CROSS SECTION A-A' COSON RESIDENCE MEGER ISLAND, WASHINGTON

FIGURE 3

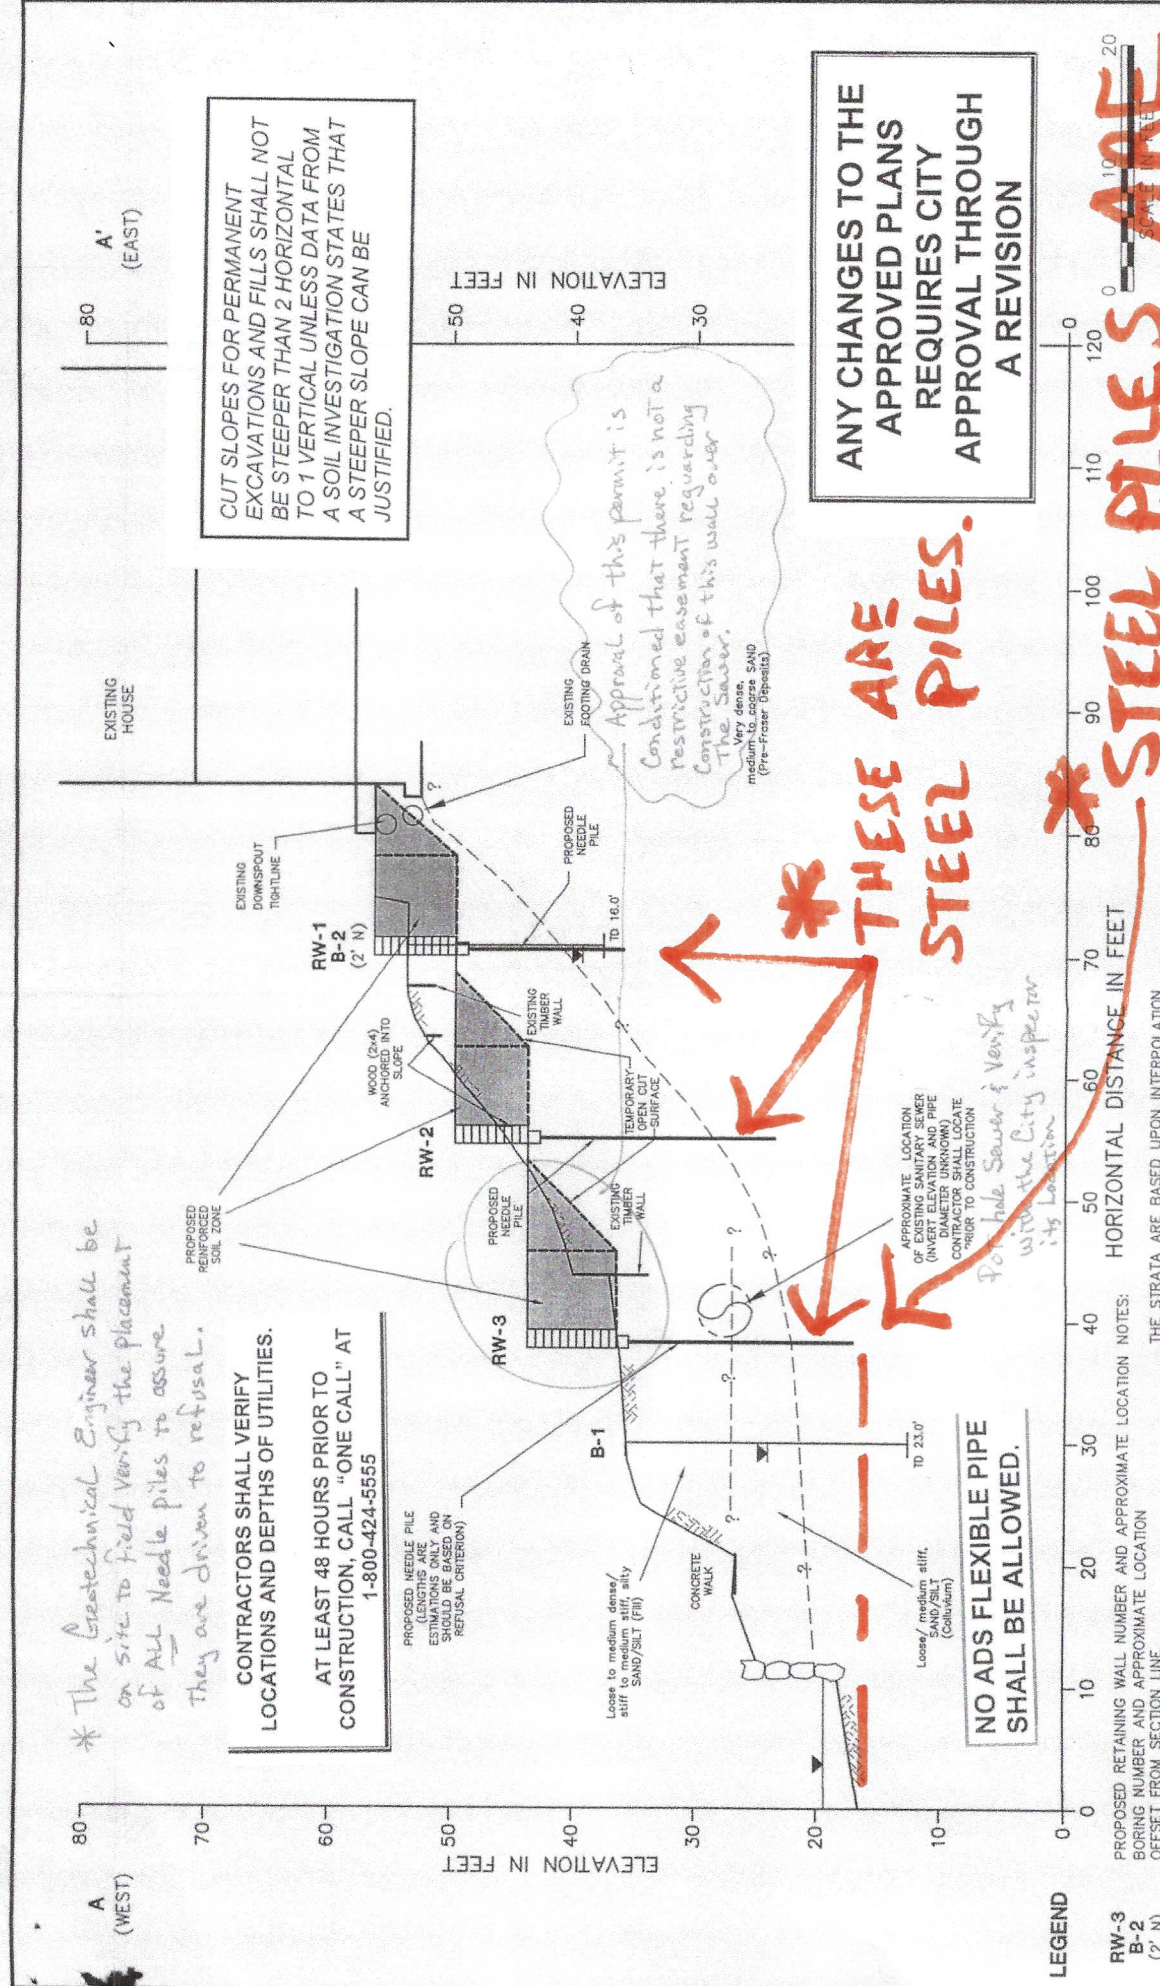
* The Geotechnical Engineer shall be on site to field verify the placement of ALL Needle piles to assure they are driven to refusal.

Approval of this permit is conditioned that there is not a restrictive easement regarding the sewer. Very dense, include to cases SAND (Fru-Fruzer) (Spanda)

THESE ARE STEEL PILES.

STEEL PILES ARE BLOWN BUCKHEAD BREAKS

NO ADS FLEXIBLE PIPE SHALL BE ALLOWED.
